④ door type 002 back leaf (L20/417)

③ door type 002 front leaf (L20/417)

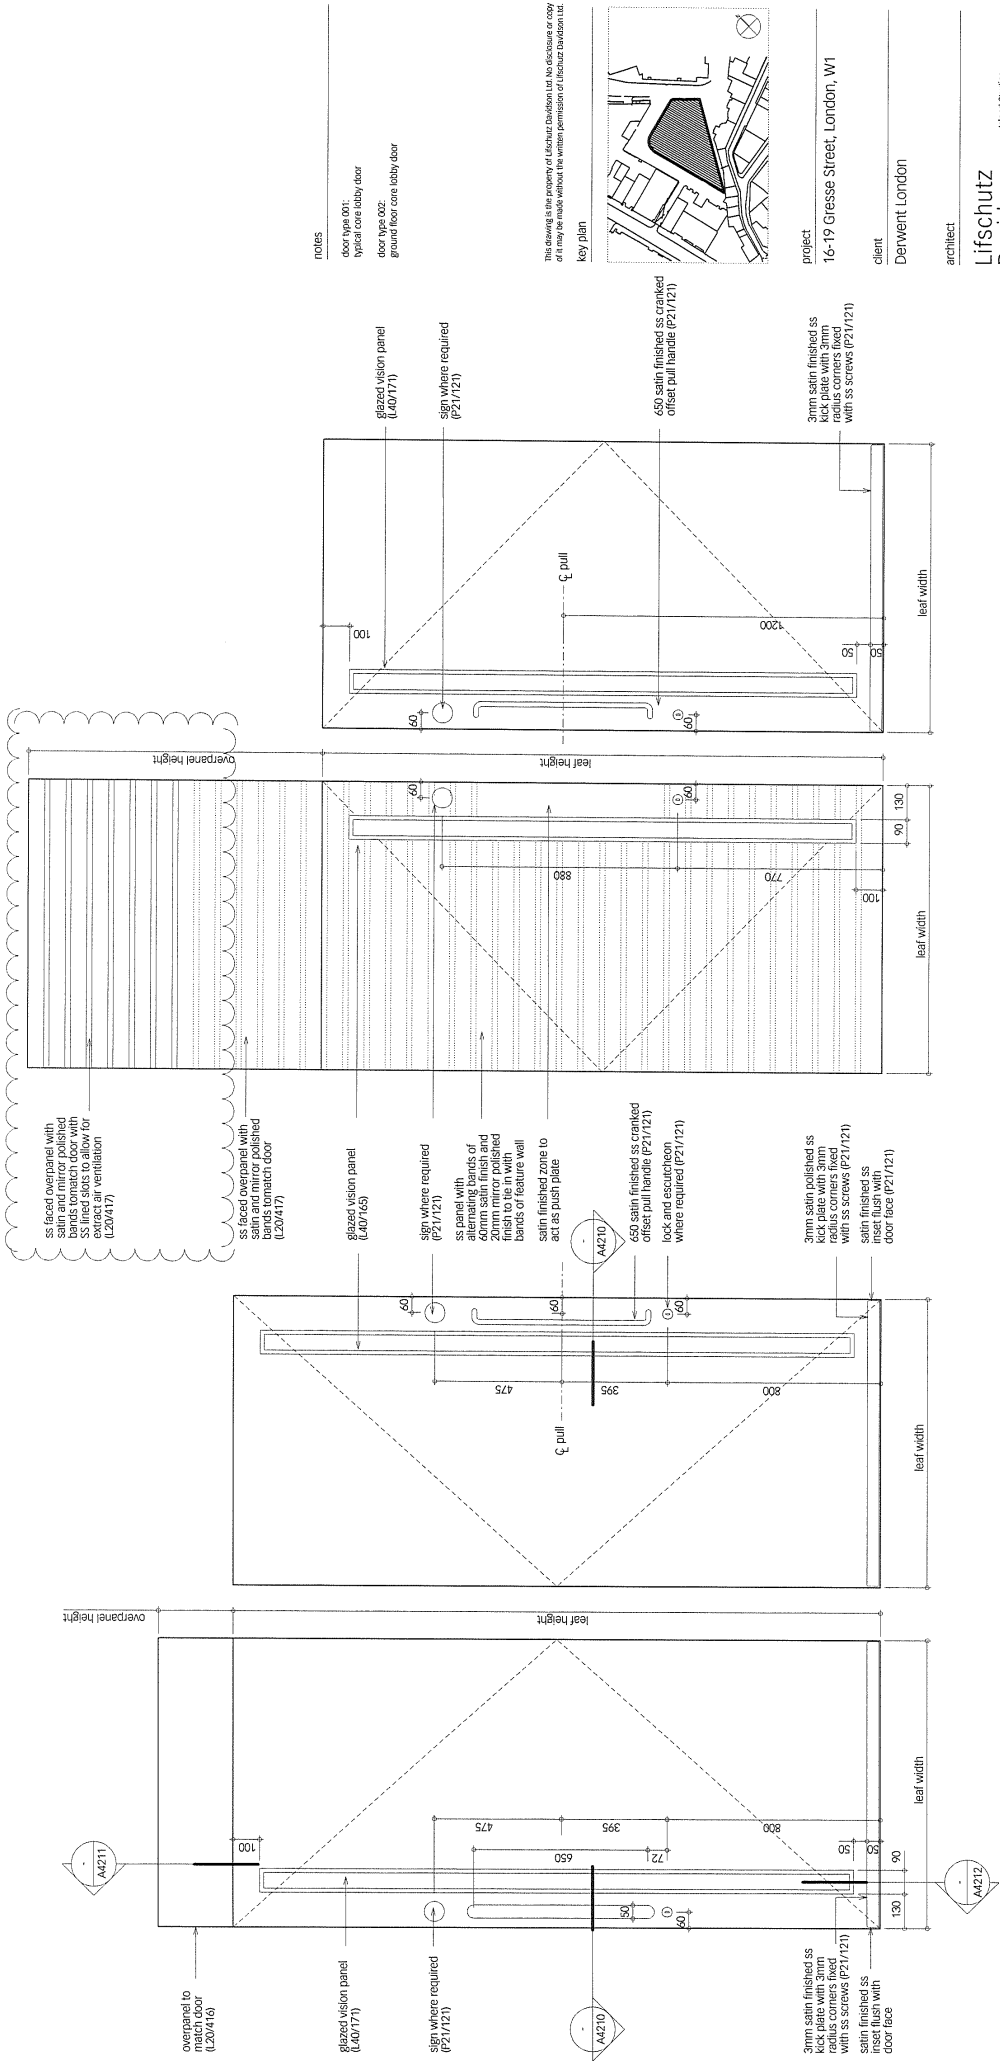
revisions	date	rev
full height ss flush inset omitted - full height vision panel revised match others - push plate omitted, dimensions added	23.06.06	A
issued for construction	23.07.07	B
Door type 002 SS lined ventilation slots added to allow for extract ventilation	14.03.08	C
